Capital Investment Review (CIR)

Written Follow-Up Responses

April 12, 2012

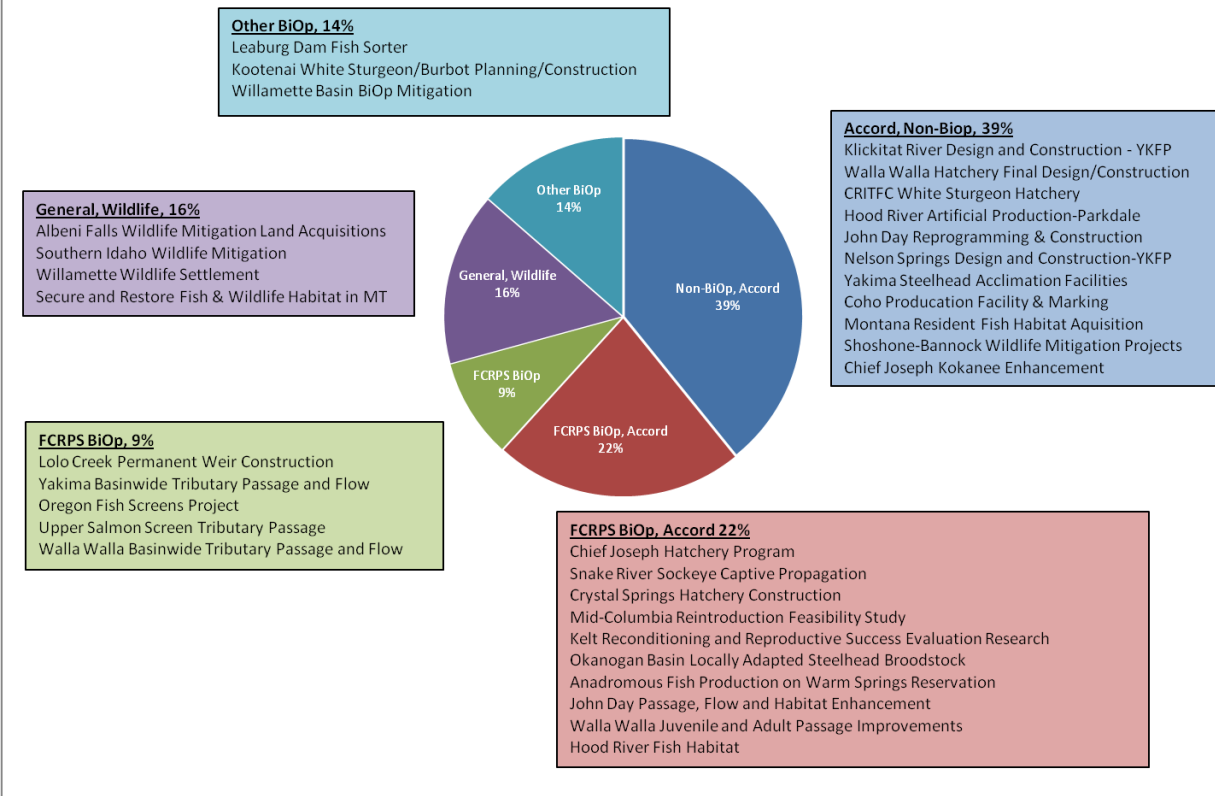
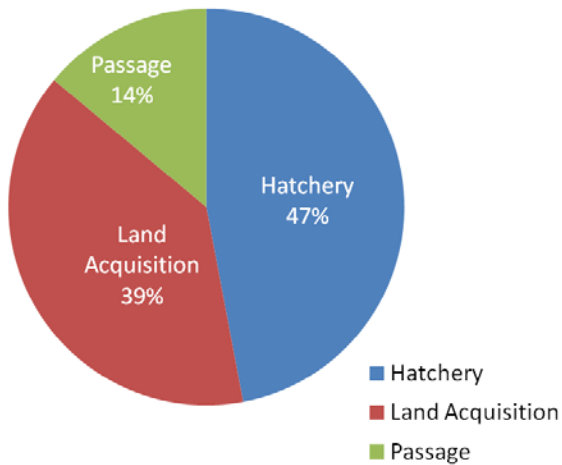
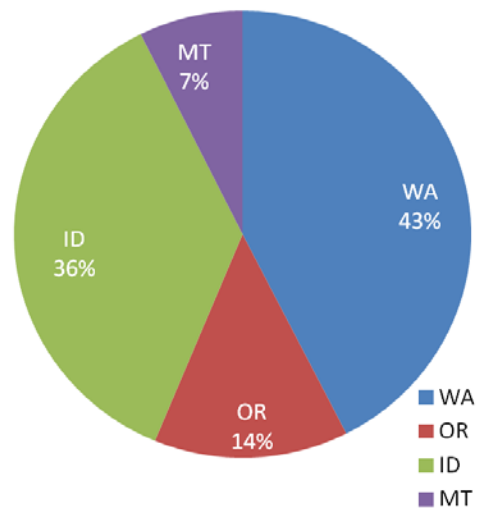
Page 121 – Please provide a breakout for FY 2013 – FY 2015 for land, hatcheries and passage of the individual projects and reference whether they are mandated by a Bi-Op, Fish Accords, or other settlement agreements.

Provide a listing of currently planned fish and wildlife projects over the ten-year period, divided up by the justification for the project (i.e. BiOp, fish accords, or discretionary).

See charts below

FY13-15 Total Budget \$169.2M
 (FY13=\$67.1M, FY14=\$60.3M, FY15=\$41.8M)
